# UNITED STATES PATENT AND TRADEMARK OFFICE

| APPLICATION NO. | FILING DATE | FIRST NAMED INVENTOR | ATTORNEY DOCKET NO. | CONFIRMATION NO. |
|-----------------|-------------|----------------------|---------------------|------------------|
| 10/057,804      | 01/25/2002  | Hideyoshi Tsuruta    | 782 215             | 9257             |

# Office Action Summary

## DETAILED ACTION

FIG. 1B

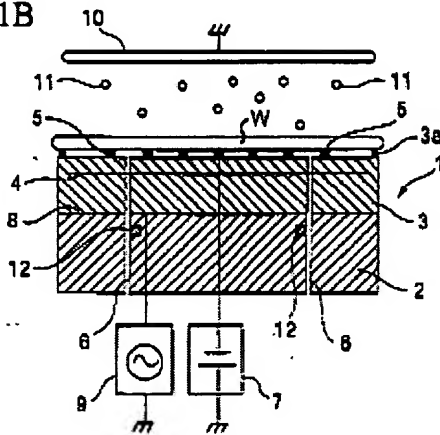
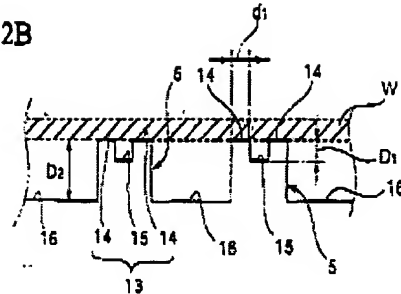
Kosakai discloses in fig. 1B, & 2B, an electrostatic chuck having an insulation layer including a mount plane on which a wafer (W) is mounted, an inner electrode provided in the insulation layer, and projecting portions (see fig. 2B) protrude from the mount plane which include contact planes to be contacted to the wafer, wherein a backside gas is flowed in a space defined by the mount plane (see col. 6 lines 38-43), the projecting portions and the wafer under such a condition that the wafer is attracted to the mount plane so as to maintain a temperature uniformly of the wafer, the heights of the projecting portions are not less than 5 microns and not more than 10 microns (see col. 7 lines 35-43).

Kosakai does not expressly state that the (chuck) has a construction such that a total amount of areas of the contact planes of the projecting portions is not less than 5 % and not more than 10 % with respect to the inner electrode. The chuck of Kosakai inherently possess this structural limitation (see col. 6-7, lines 61-67, lines 1-5, "the area ratio of the total area of the specimen holding surfaces to the total area of the attachment region 3b (area remaining after subtracting the area of the peripheral wall 3a

from the area of the dielectric layer) should be 0.5-30%"; and fig. 1B illustrates the internal electrode having the same surface area as the 3b).

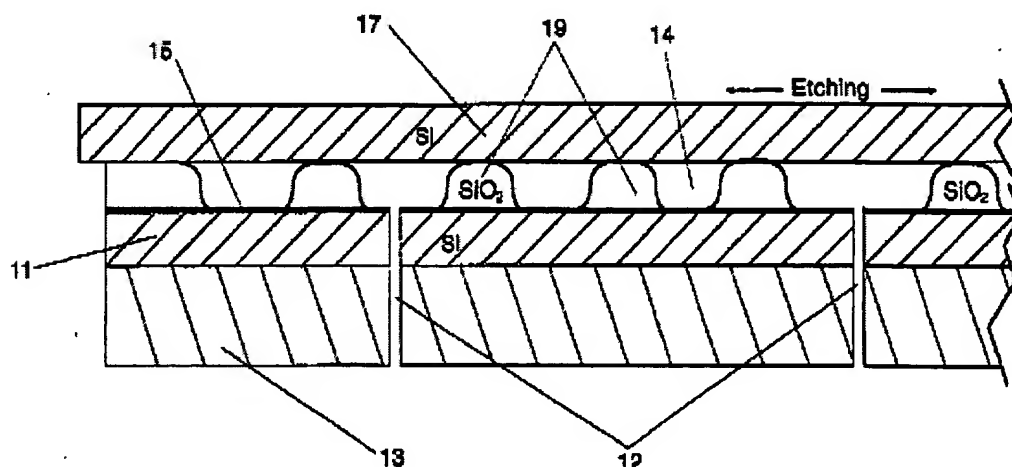
Anderson et al. disclose in fig. 1, an electrostatic chuck having an insulation layer (15', 19) including a mount plane on which a wafer (17) is mounted, an inner electrode (11) provided on the insulation layer, and projecting portions (19) protrude from the mount plane which include contact planes to be contacted to the wafer, wherein a backside gas is flowed in a space defined by the mount plane (co. 4 lines 15-40), the projecting portions and the wafer under such a condition that the wafer is attracted to the mount plane so as to maintain a temperature uniformly of the wafer, the heights of the projecting portions are 5 microns (see col. 5 lines 35-50).

Anderson et al. do not expressly state that the (chuck) has a construction such that a total amount of areas of the contact planes of the projecting portions is not less than 5 % and not more than 10 % with respect to the inner electrode. The chuck of Anderson et al. inherently possesses this structural limitation (see col. 4 lines 45-50) the chuck-face area occupied by the islands would fall in the range of 0.5 % to 5 %; and fig. 1 illustrates the internal electrode having the same surface area as the fraction of the chuck-face area).
